Office Action Summary	Application No. 10/534,493	Applicant(s) BETTINZOLI, ANGELO	
	Examiner JORGE PEREIRO	Art Unit 3743

DETAILED ACTION

3. Claims 1-5 and 8-16 are rejected under 35 U.S.C. 103(a) as being unpatentable over US Patent Application Publication No. 2001/0010897 to Dane (hereinafter "Dane") in view of German Patent No. DE 44 27 953 to Joos et al. (hereinafter "Joos").

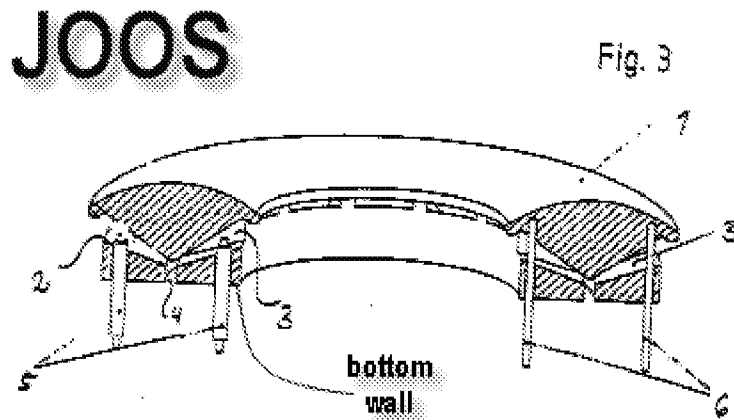
6. Nonetheless, with reference to figure 3 below, Joos teaches a gas burner for a cooking hob wherein a means (4) for feeding at least one flame ring (see figure 3 below) comprises at least one horizontal mixing chamber (3) with a radial Venturi effect (*see at least* figures 3); wherein said horizontal mixing chamber is formed by top (see 1) and bottom (referenced in figure 3 below) horizontal walls, the bottom wall having an inflow hole (4) at a central portion thereof such that the primary air and the gas flow from the inflow hole radially and generally parallel to the top and bottom horizontal walls; further comprising a top covering element (1) of said at least one external body, an upper wall of said at least one horizontal mixing chamber (3) with a radial Venturi effect of the means for feeding said at least one external body coinciding with a lower wall of said covering element.

11. Nonetheless, with reference to figure 3 above, Joos teaches a gas burner for a cooking hob with at least one horizontal mixing chamber (3) with a radial Venturi effect (*see at least* figure 3) to separately feed the mixture of primary air and gas to at least one flame ring; wherein said horizontal mixing chamber is formed by top (*see* 1) and bottom (referenced in figure 3 above) horizontal walls, the bottom wall being having an inflow hole (4) at a central portion
